ADDENDUM # 4

Project	TA Blakelock High School Renovations	Project No.	2215-C
Location	1160 Rebecca Street, Oakville, ON	Date of Issue	2025 05 02
Owner	Halton District School Board	File	2215/7.1.3

This Addendum forms part of the Contract Documents and amends the original Drawings and Specifications, dated 2025 04 17, and all preceding Addenda, as noted below.

HIGH ROOF FRAMING PLAN
SCALE: 1:100

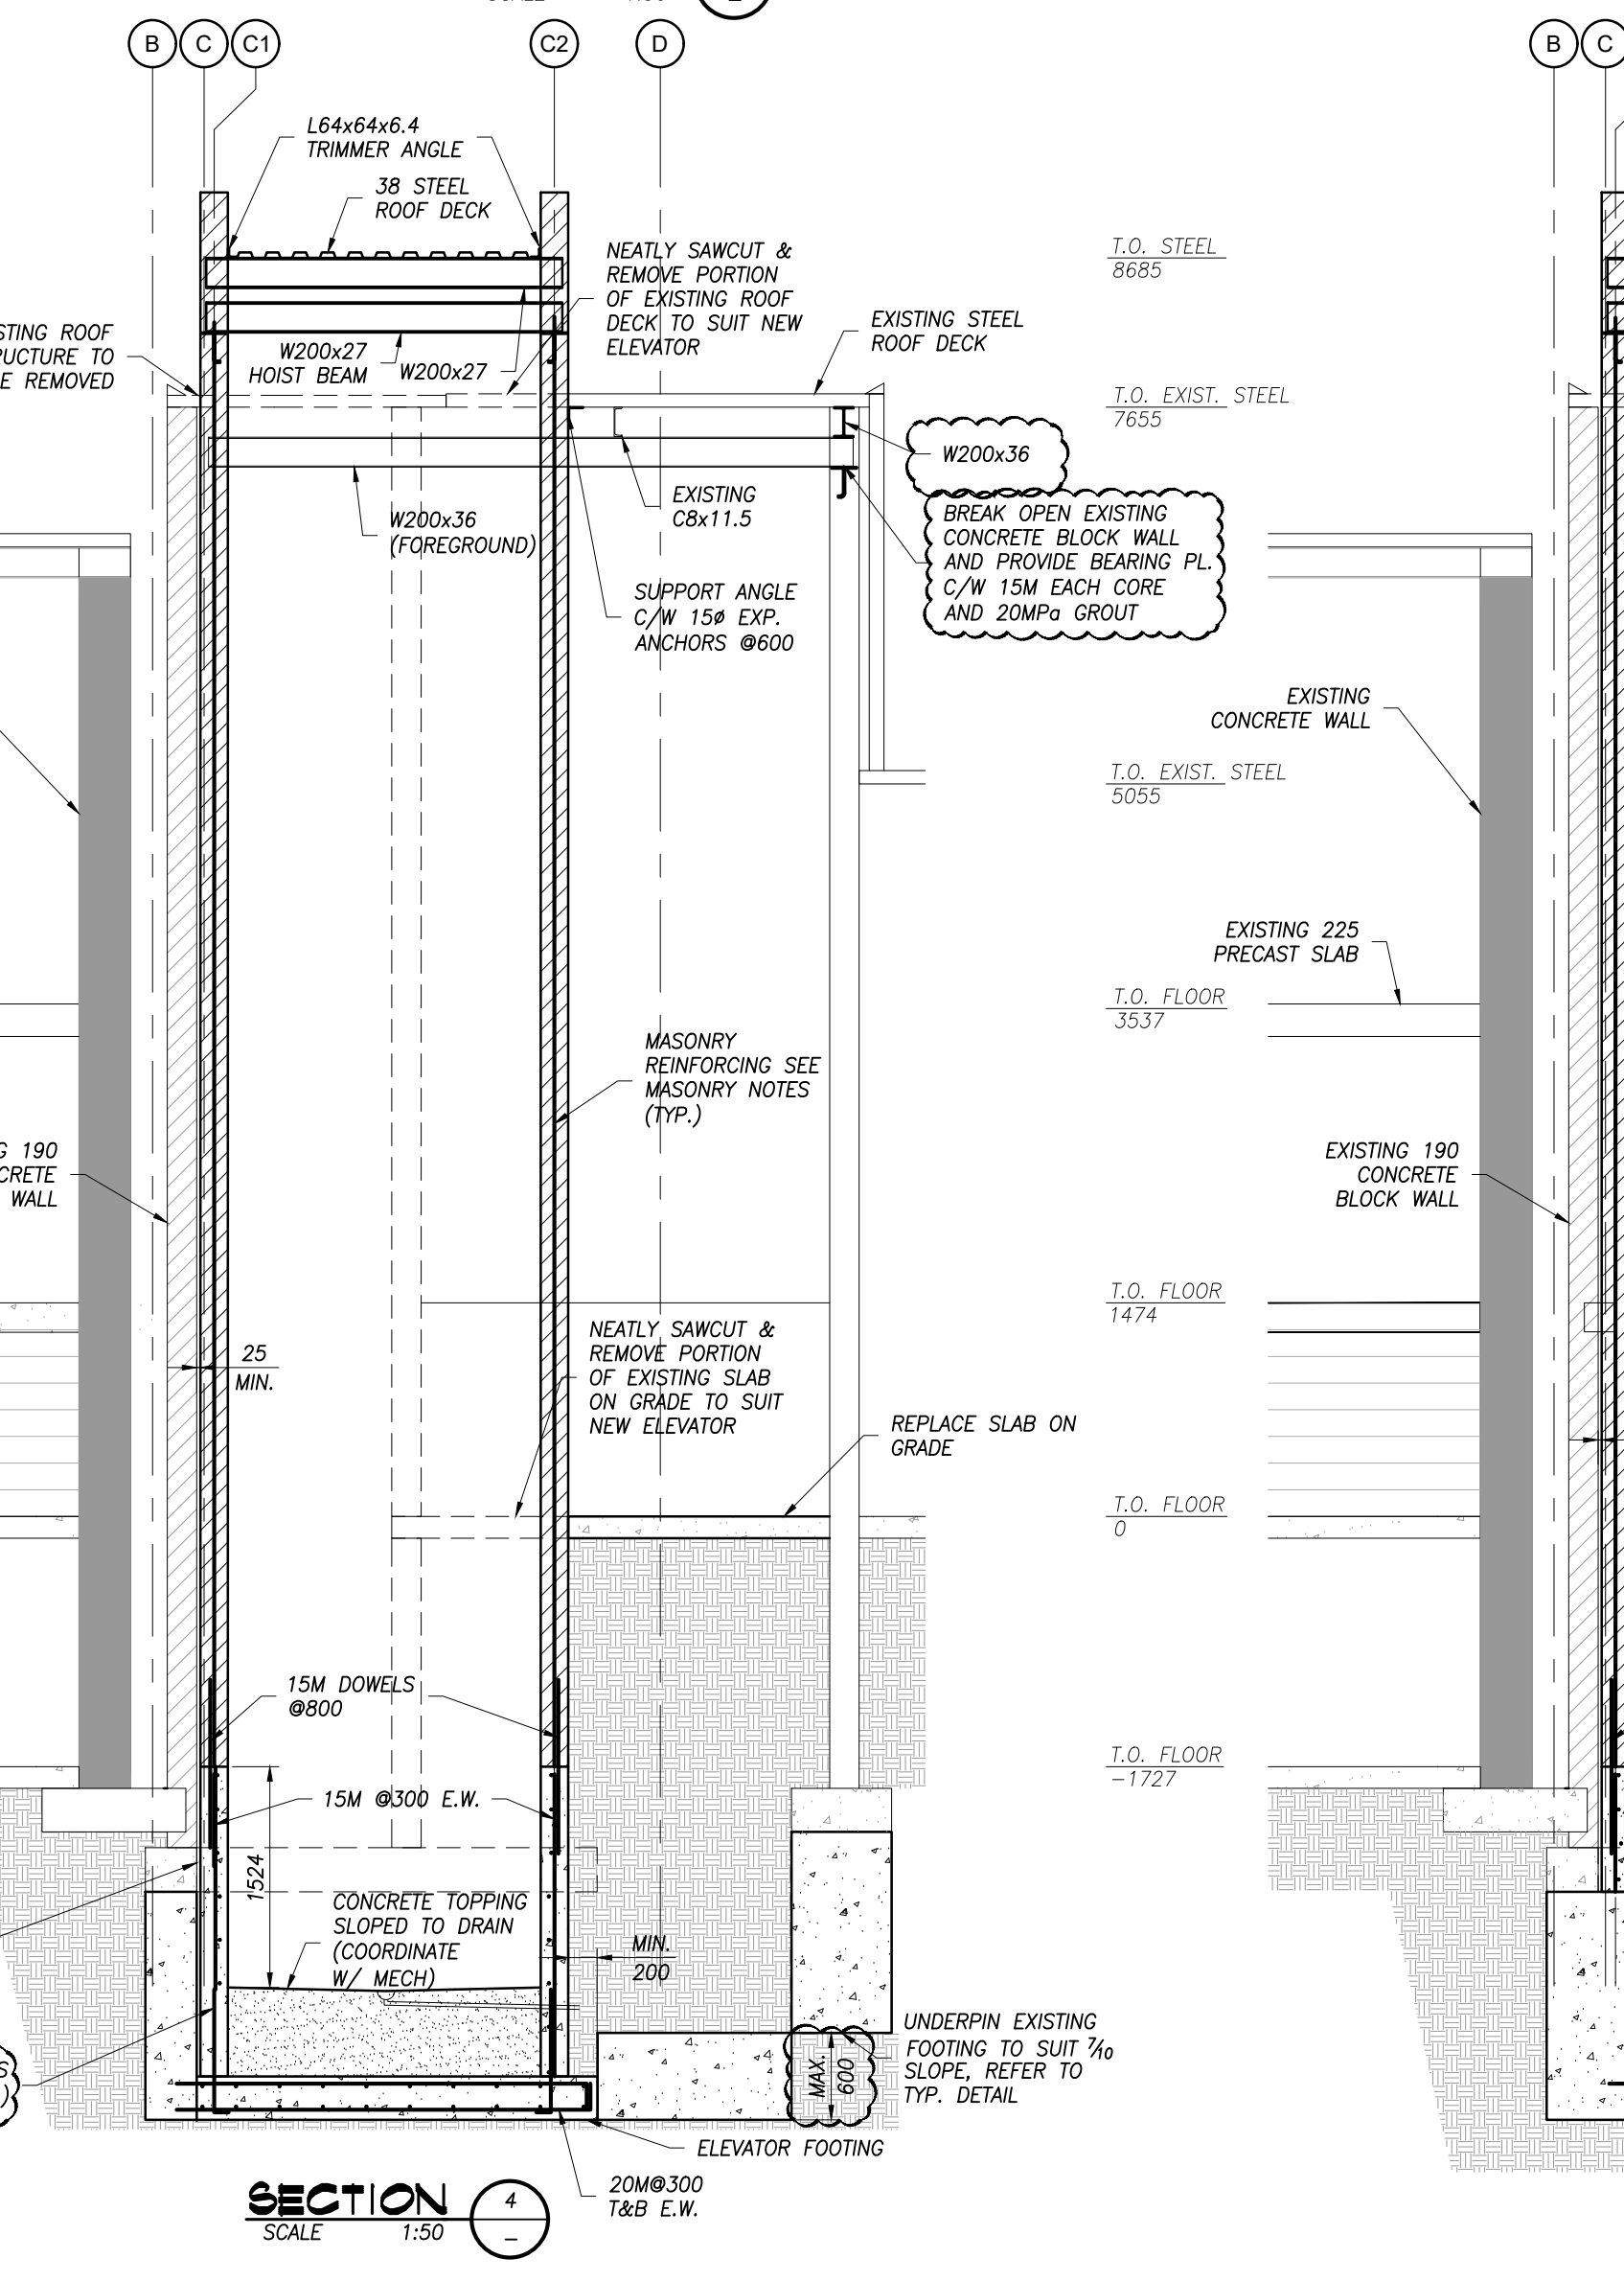
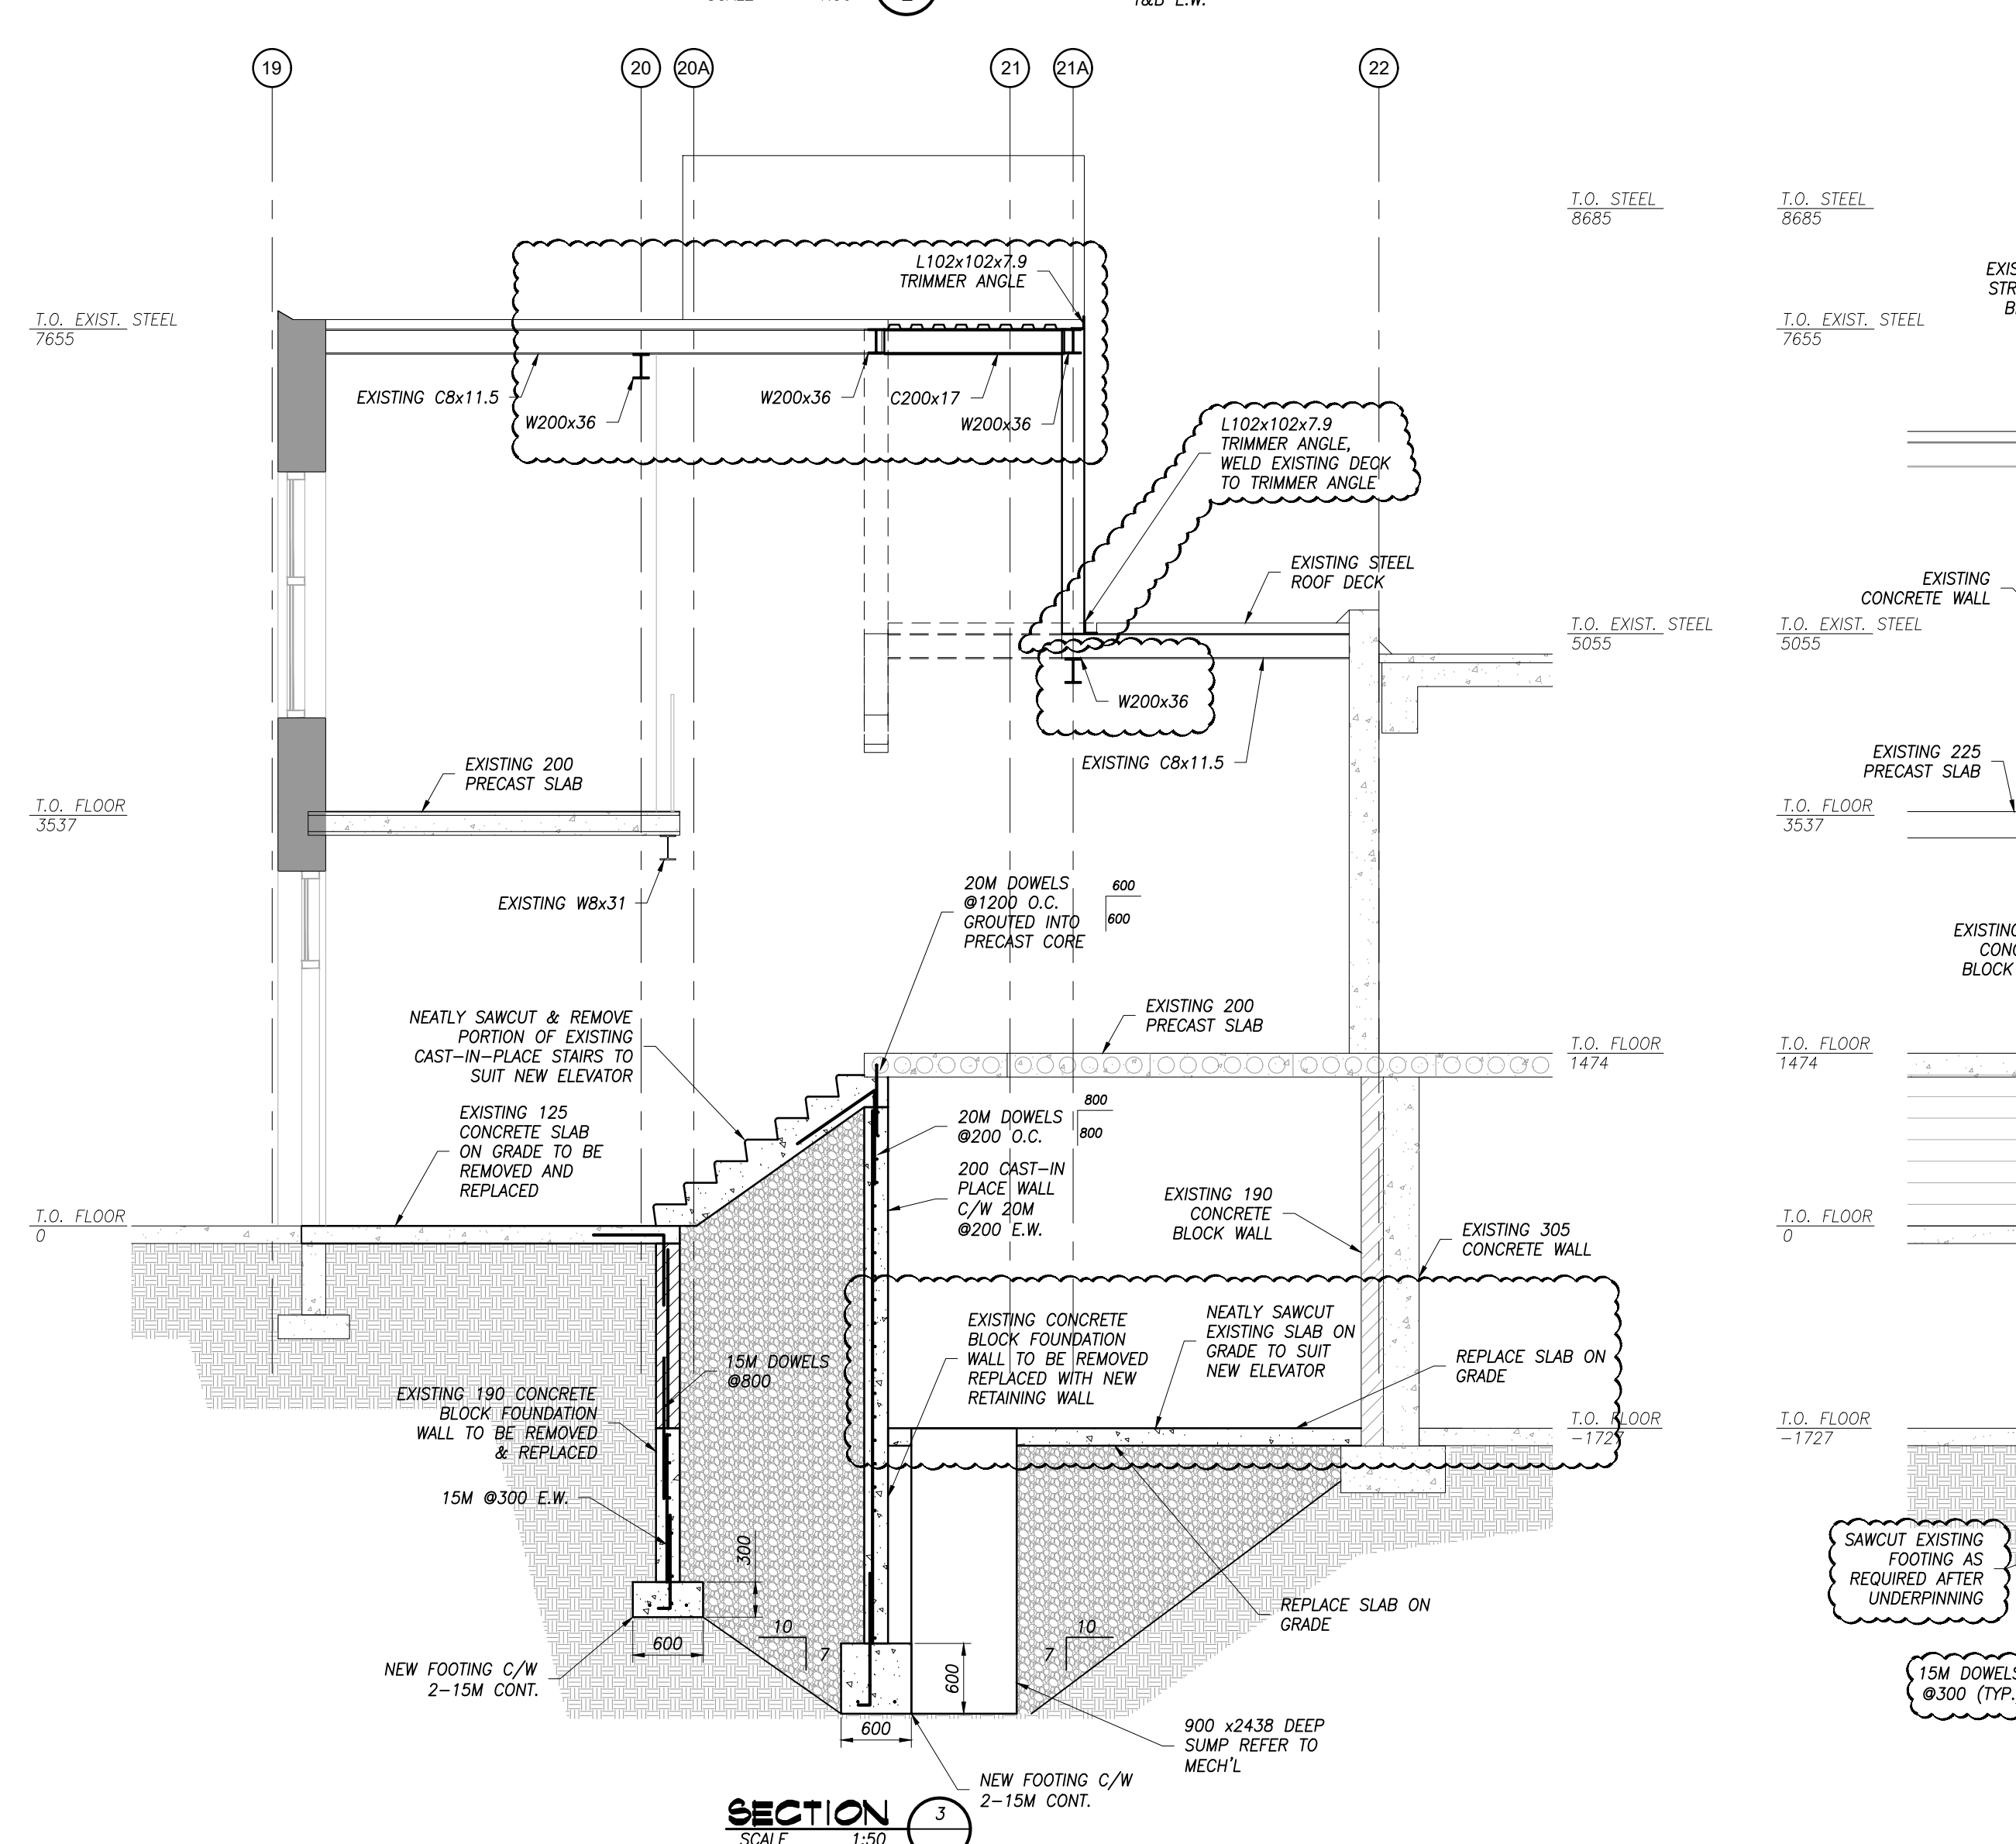
- A. Drawing S000:
 - a. General Steel Deck notes added to the drawing.
- B. Drawing S100:
 - a. Extent of grouting existing foundation wall for new column clarified.
- C. Drawing S200:
 - a. West Elevator framing updated to match architectural sections.
- D. Drawing S300:
 - a. East Elevator framing updated to match architectural sections.
